Executive Director's Recommendation

Commission Meeting: October 3, 2013

PROJECT Reconstruction of South Capitol Street, P Street to I-295 South Capitol Street Washington, DC	NCPC FILE NUMBER 7529
	NCPC MAP FILE NUMBER 8.10(48.31)43847
SUBMITTED BY District of Columbia Department of Transportation	APPLICANT'S REQUEST Approval of comments on concept design
REVIEW AUTHORITY District Project Outside the Central Area 40 USC § 8722 (b)(1)	PROPOSED ACTION Approve with comments
	ACTION ITEM TYPE Staff Presentation

Figure 6: Supplemental EIS Bridge Alignment

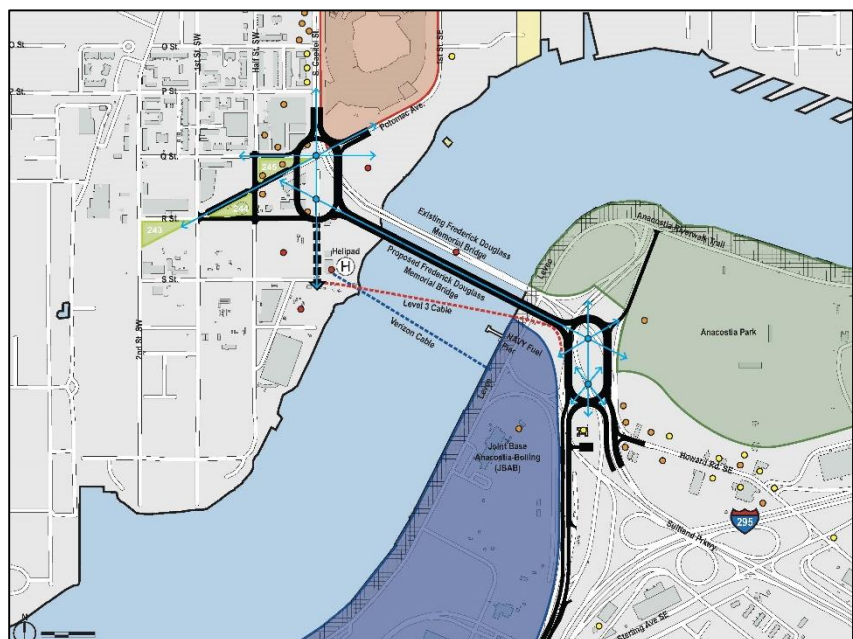
- **Recommends**, as it continues with the design development, that the District Department of Transportation:
 - Determine which land transfers are necessary as part of this reconstruction process, and

Figure 10: West and East Ovals – Concept Design

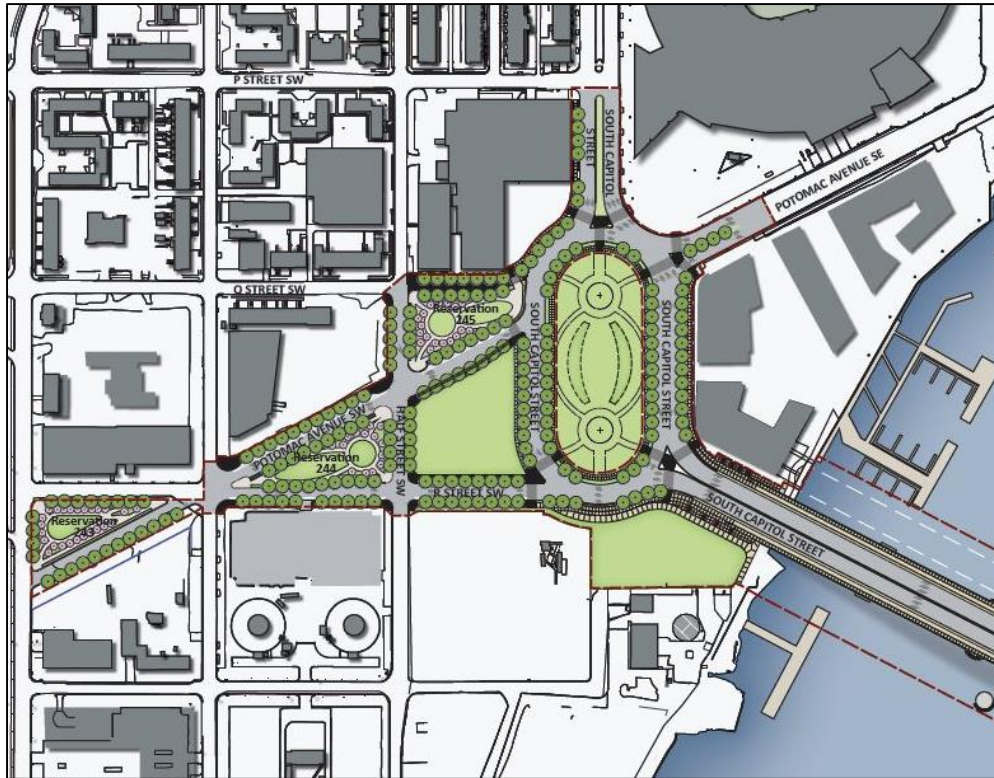
- **Comments** favorably on the two oval open spaces that are proposed on either side of the Anacostia River at the Frederick Douglass Bridge, but also

- Explore various options on which agency could best manage the oval open spaces.
- **Notes** that future land use discussions concerning the land around the western oval, although outside of the scope of this project, will need to occur to help further the ideas of creating a vibrant destination as identified in several plans for this area.

2. Oval Traffic Rotary – this proposal includes two rotaries on either side of the Anacostia River. Both oval open spaces are approximately 3 acres in size each. A 6-acre oval was proposed, but this is not possible given the roadway configuration and site constraints. The development surrounding these open spaces, especially the western oval that has an axial relationship to the U.S. Capitol, will be key in helping to define this important space.
